December 18, 2024

PROJECT NAME: BOWMAN 326 DEVELOPMENT

PROJECT NUMBER: 2023080108

APPLICATION: MAJOR SITE PLAN #30575

A MARION COUNTY MAJOR SITE PLAN FOR  
**BOWMAN 326 DEVELOPMENT**  
MARION COUNTY  
Layout Plan (2 of 2)

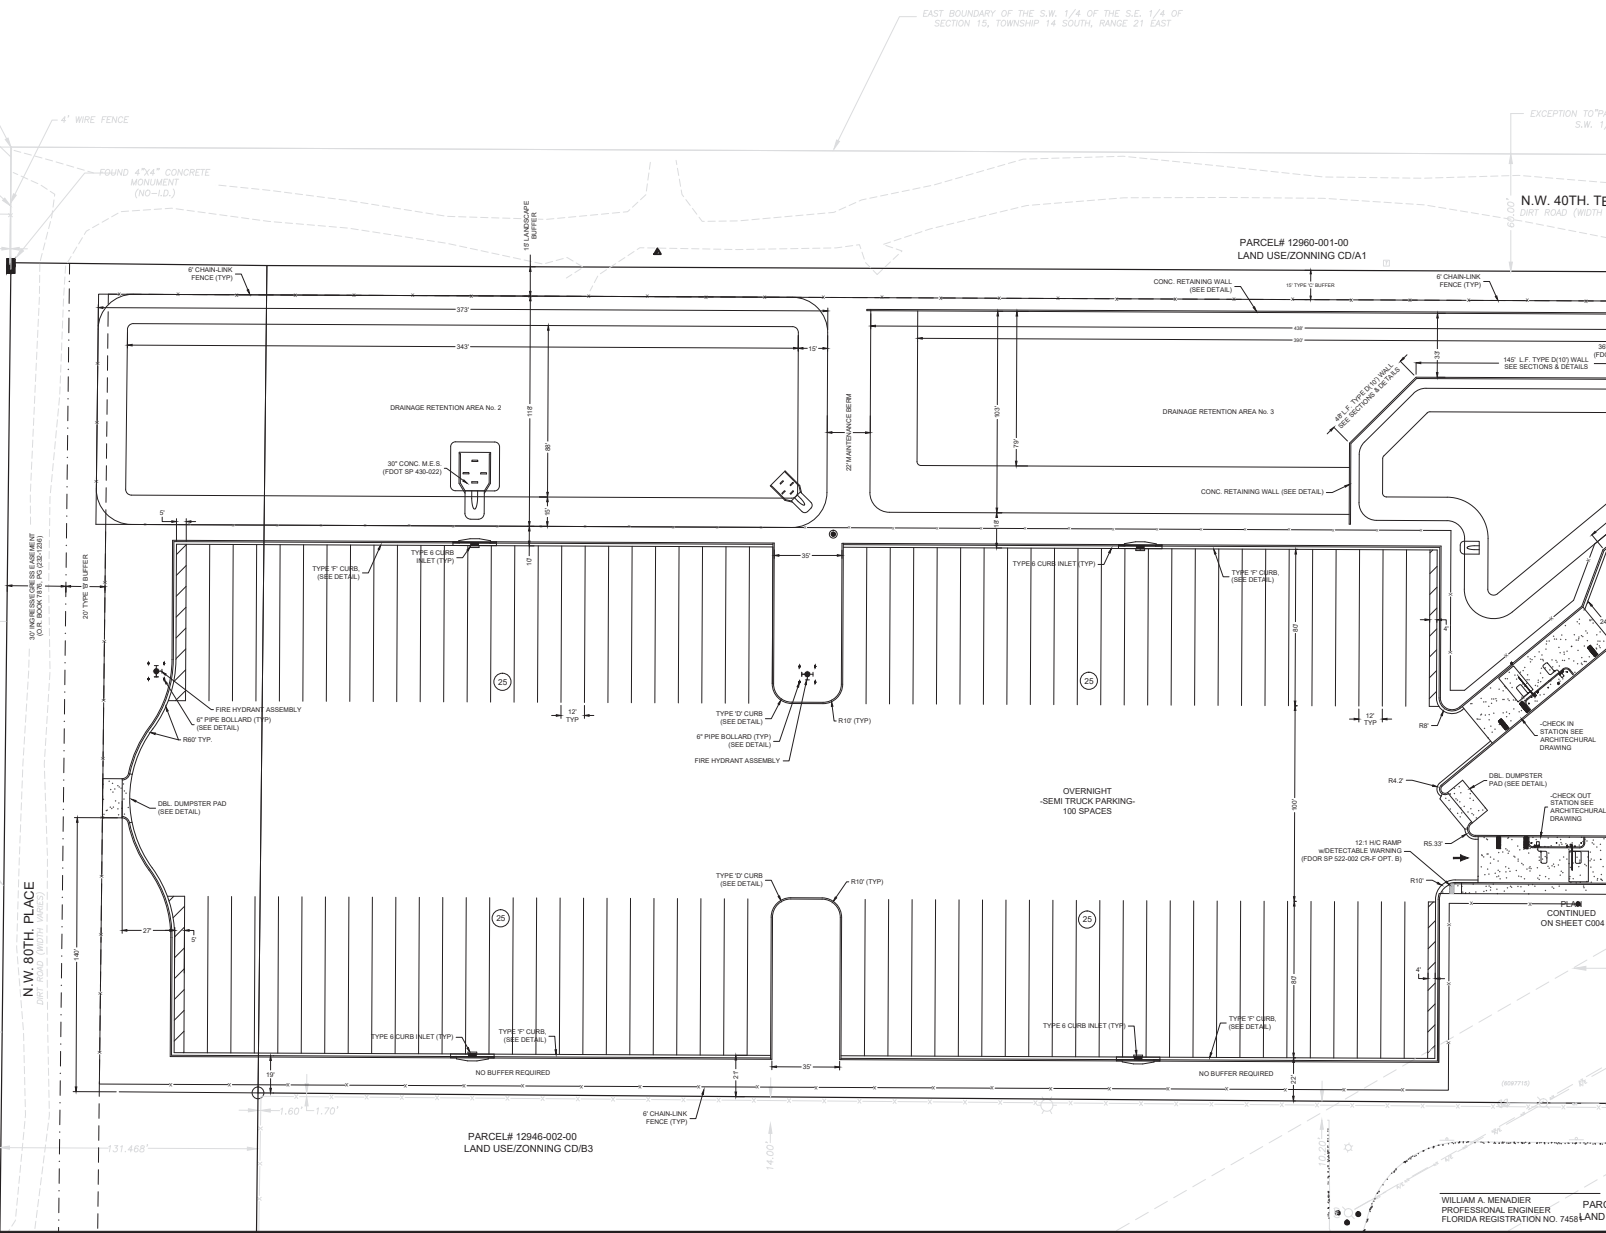
- 32 DEPARTMENT: 911 - 911 MANAGEMENT  
REVIEW ITEM: 2.12.28 - Correct road names supplied  
STATUS OF REVIEW: NO  
REMARKS: Sheets C008 and L004 were not resubmitted, therefore W HWY is still incorrectly labeled as State Road 326. Sheets L001 and L002 still have W HWY 326 incorrectly labeled as County Road 326.

A MARION COUNTY MAJOR SITE PLAN FOR THE  
**BOWMAN 326 DEVELOPMENT**  
MARION COUNTY  
Grading & Drainage Plan (1 of 2)

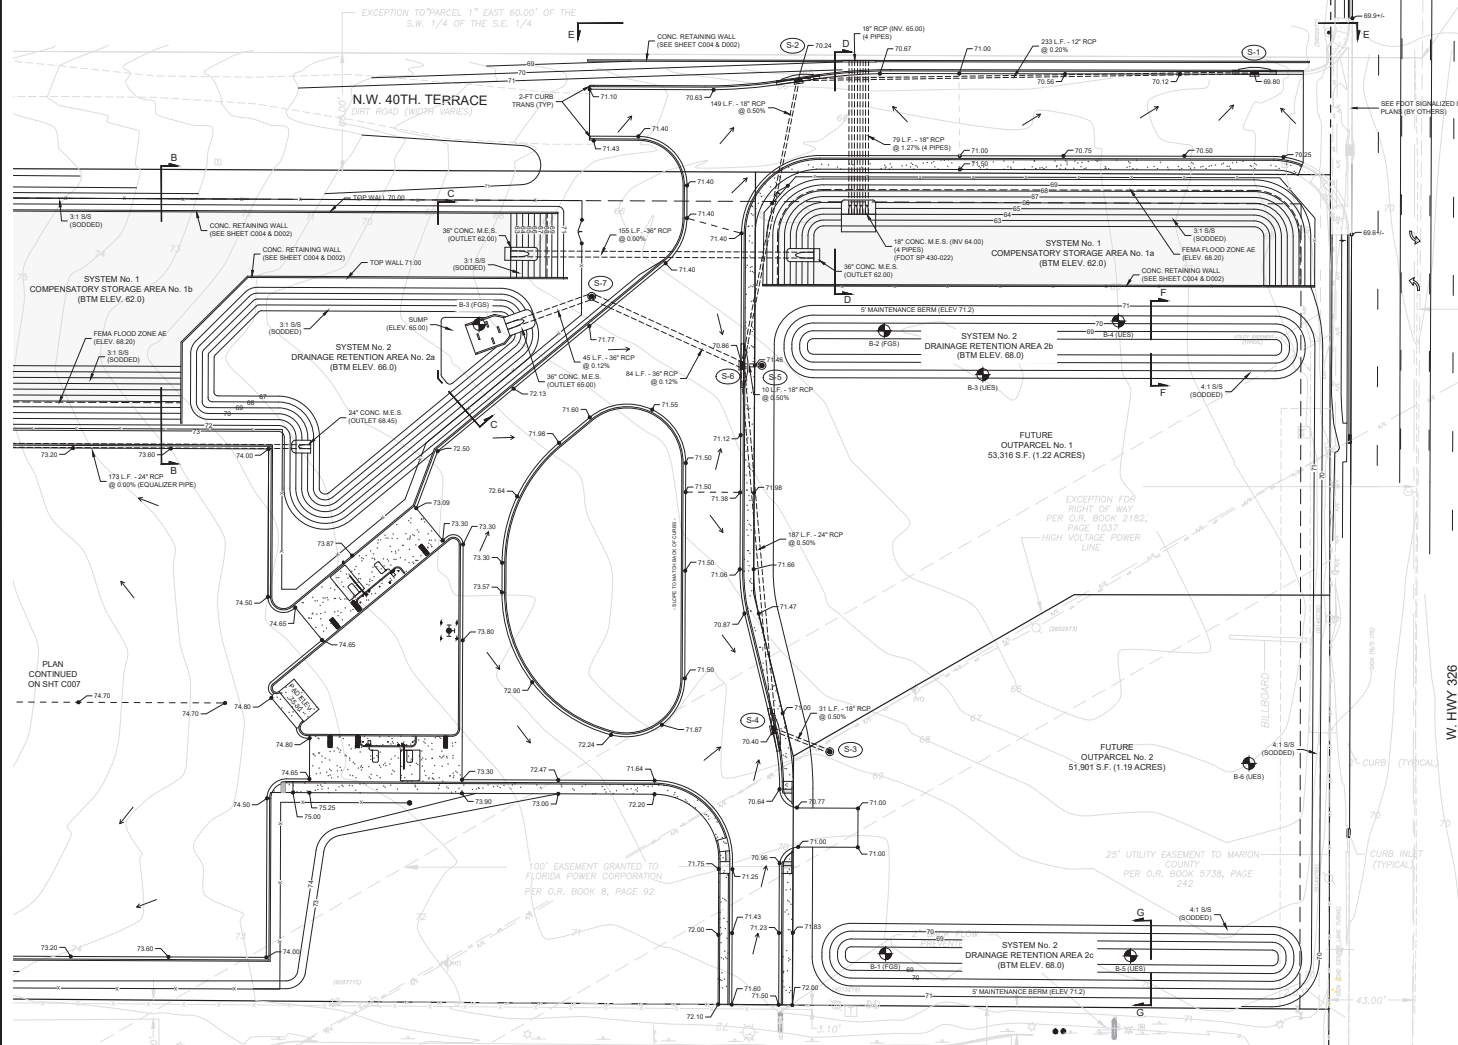
- 28 DEPARTMENT: ENGDRN - STORMWATER REVIEW  
REVIEW ITEM: 7.1.3 - Drainage Construction Specifications  
STATUS OF REVIEW: NO  
REMARKS: LDC requires the use of RCP pipe for stormwater conveyance piping. To pursue using an alternative material, the engineer needs to submit a request identifying the alternative material type requested, verification that the material is included on the FDOT Approved Products List, and the site specific installation meets install criteria such as depth of cover and UV protection for pipe ends. County will review the request and provide feedback. Section of pipe north of curb inlet S-12 is identified as using HDPE
